# ***West Parcel Solar Project***

*Project Final Tiered EIR*

## ***Volume 3 Response to Public Comments on the Draft EIR***

*MT. SAN ANTONIO COLLEGE  
Facilities Planning and Management  
Walnut, California*

Hillside Losses from Solar Project Traveling from Snow Creek to Amar Road

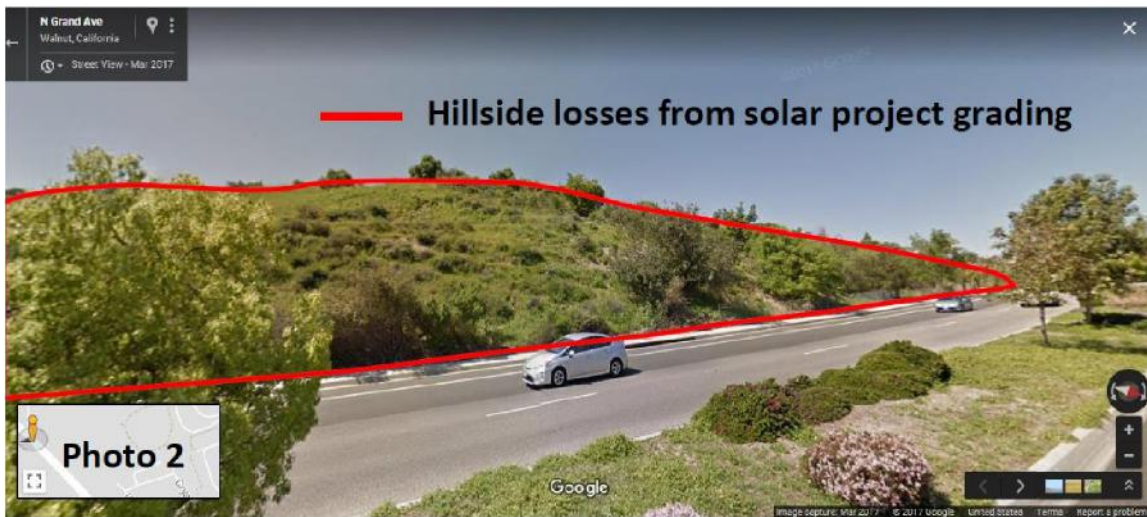
- 5. Motorists traveling Grand Avenue would observe loss of hillsides, which is inconsistent with the General Plan Scenic Corridor designation of the roadway. The following views of Grand Avenue (photos 1 through 3, below) traveling from south to north from Snow Creek Drive to Amar Road displays the scenic values of Grand Avenue at street level and the significant destruction of native hillsides and vegetation caused by the west parcel project.

**Response 5.2.5.** The photos of the project frontage (photos 1 – 3) prior to development presents an incomplete portray of the project. Generally, pre- and post-development photos are presented for a project, so the reader can determine how the project is viewed when graded and landscaped. The District has already presented pre- and post-project photos in Appendix J of the Draft EIR. The comments seem to presume that any loss of hillsides is significant and development onsite should not proceed. This is contrary to the District’s objectives and legal issues related to the project site.

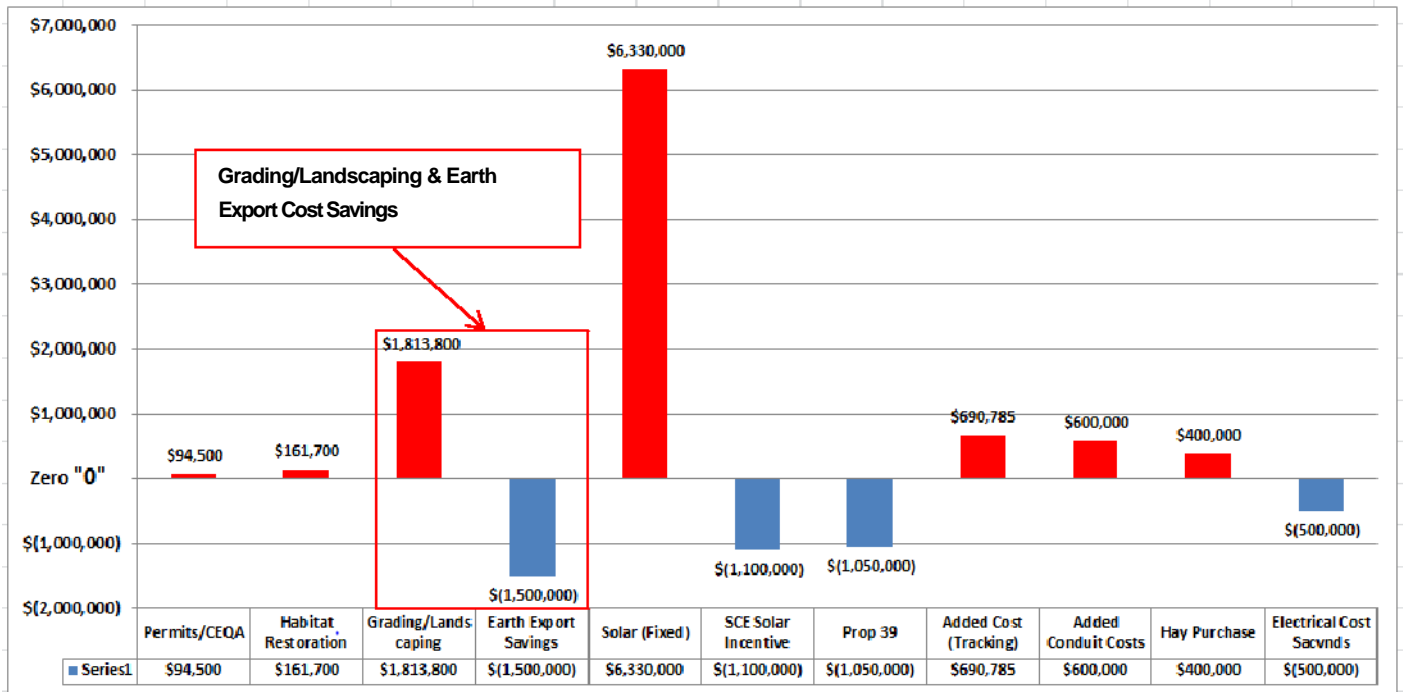
30. Given realistic unit prices in the range of \$14 per cubic yard, and earthwork quantities described above, the total grading cost was determined to be \$6,685,000 (see below), making the west parcel significantly more costly than solar panels mounted atop parking canopies or parking structures.

The comment in Item 30 is noted. Table 6.6.1 states a \$1,813,800 estimate for grading/landscaping for the project. It is highly unlikely that the \$ 8.2 million estimate for earthwork cost is reliable.

Total Project Cost - West Parcel (DEIR)  
Combined Grading/Landscaping & Earth Export Savings

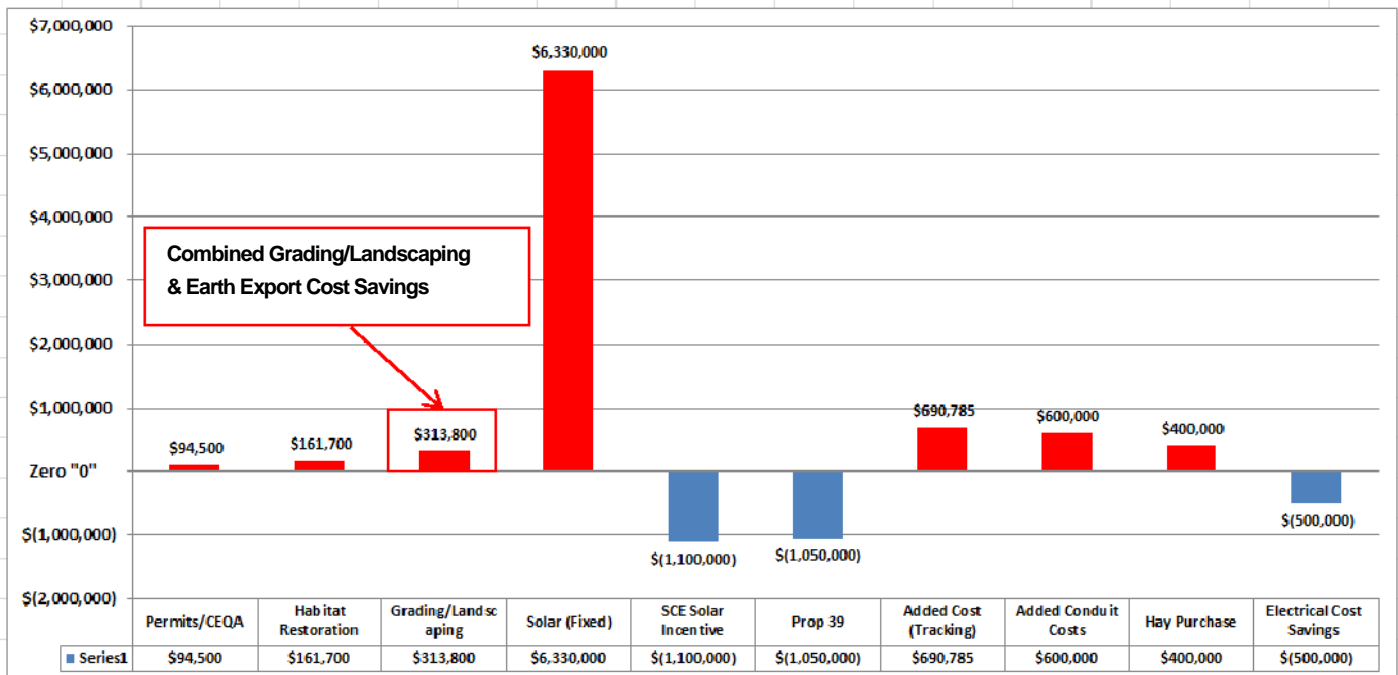
33. These costs also do not account for possible additional remediation of landslides associated with High Landslide Potential lands identified on the LA County Engineer mapping for the City of Walnut General Plan and on the California Geological Survey CGS 88-21 Map No. 12 for this region, designating most lands at the west parcel at “close to their stability limits”.

The comments in Items 31 – 34 primarily are explanations of the assumptions used in the following table. The first table (Series 1) displays the data included in Table 6.6.1 in the Draft EIR and the second table is similar, except it combines the grading/landscaping estimate and the earth export cost saving estimate. No new information is provided by the two tables.

Total Project Costs  
West Parcel (DEIR) vs. Parking Canopy Mounted Solar Pa

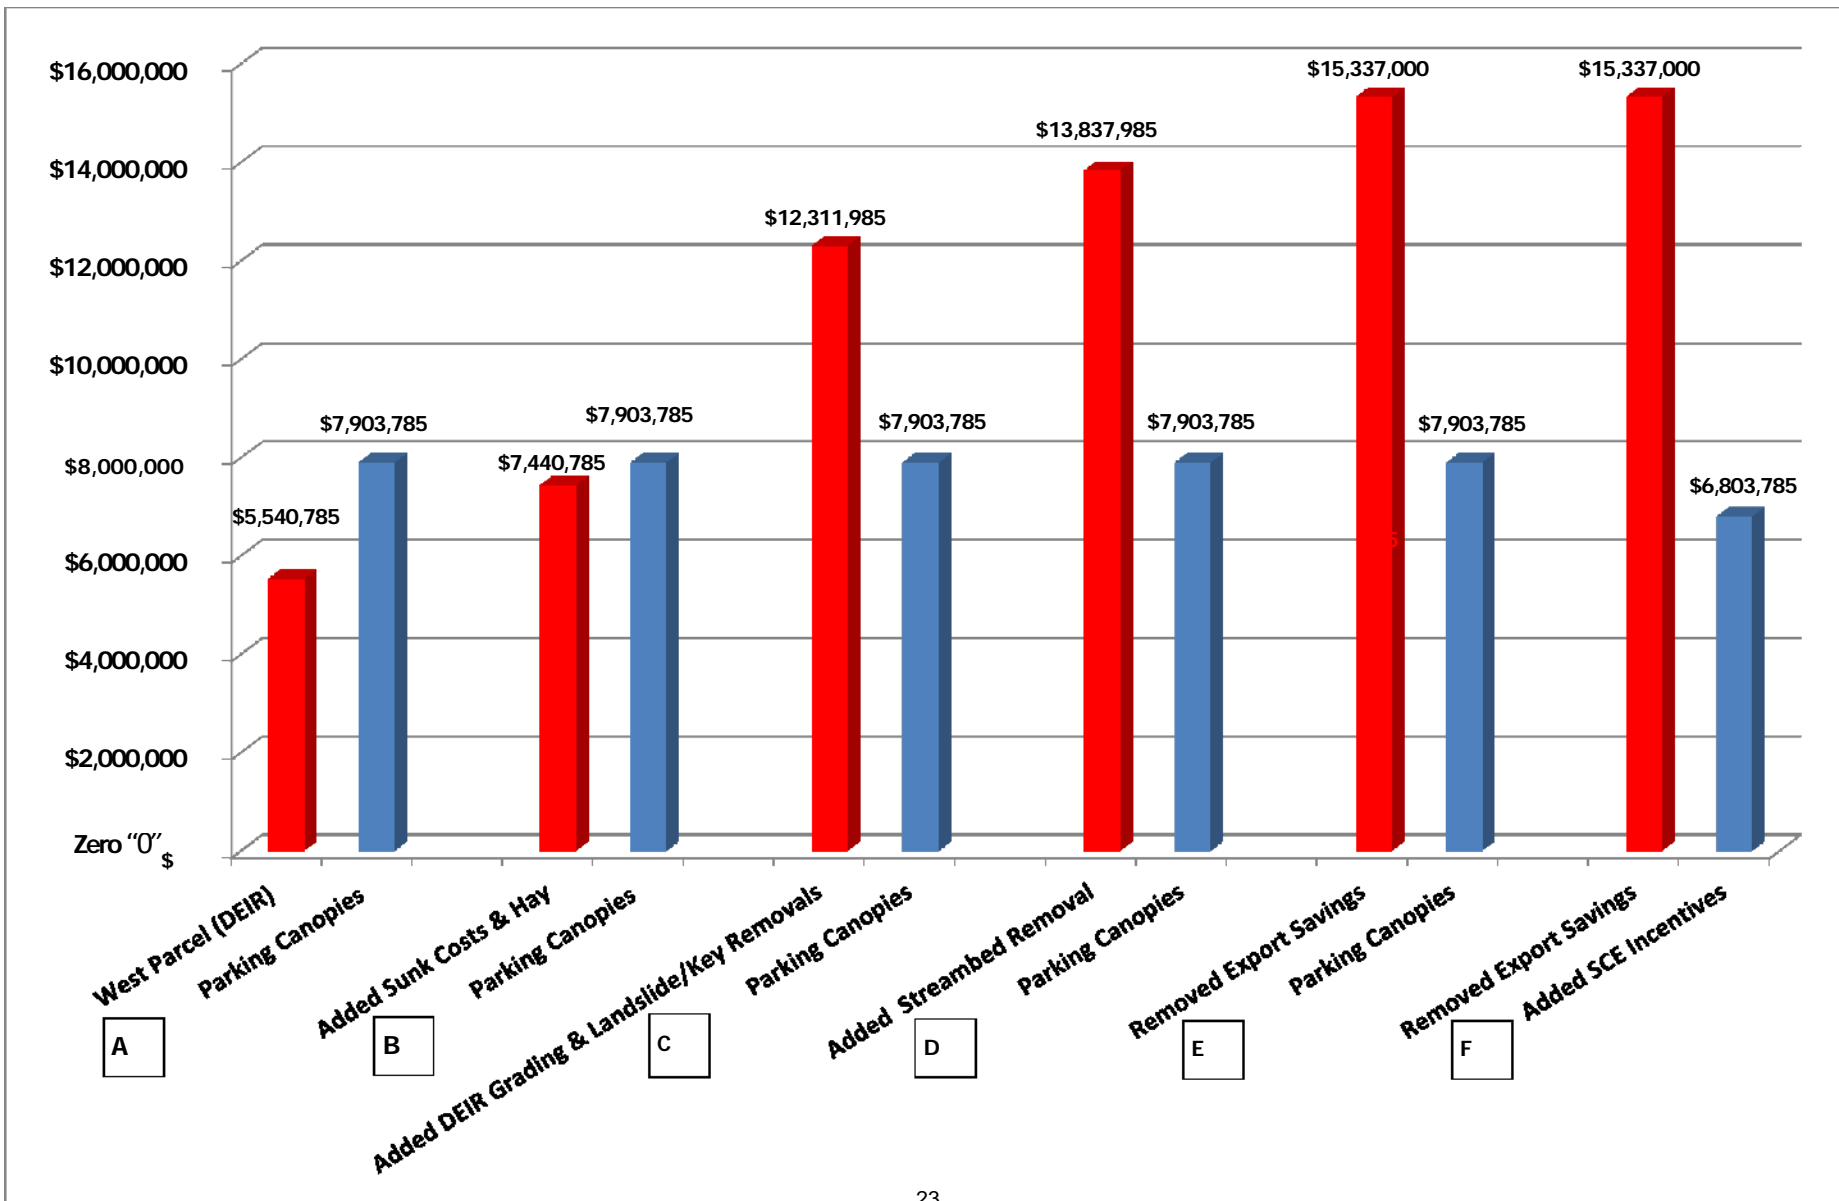
- 41. Within the following table, the total west parcel cost in Vertical Bars C is \$12,311,985. This cost includes the cost adjustments and credits applied by Mt. SAC, which if excluded, would yield the hard dollar construction costs of the project equal to \$13,271,300. This cost is based on grading quantities from Psomas grading plans and landslide removals characterized in the DEIR. When multiplying these quantities by unit costs of local and statewide contractor bids for similar work and quantities, it produces the \$13,271,300 value. This value compares favorably to the \$13,723,645 Total Project Budget including Site Improvements and Earthwork identified in the Mt. SAC Board of Trustees Action for Professional and Design and Consulting – added Services (contract Amendments), page 37, October 12, 2016.

42. Economic studies to assess ROI & Payback (Table 6.6.2) have been based on the west parcel project Net Cost of \$5,440, 785. Because these costs are considered unreliable as noted above, they should not be relied upon for development of ROI & Payback studies or for decision-making.

**Response 5.2.18.** The comment in Item 41 regarding the \$13,723,645 Total Project Budget including Site Improvements and Earthwork identified in the Mt. SAC Board of Trustees Action for Professional and Design and Consulting – added Services (contract Amendments), page 37, October 12, 2016 is noted.

However, as stated previously, construction cost is not the sole criteria used to compare the benefits of the project and a canopy mounted systems. All of UWT cost comparisons ignore the opportunity costs for future facilities that cannot be built in land devoted to a canopy solar system and do not comment on the environmental issue comparisons for project alternatives, as shown in Table 6.6.3 of the Draft EIR.
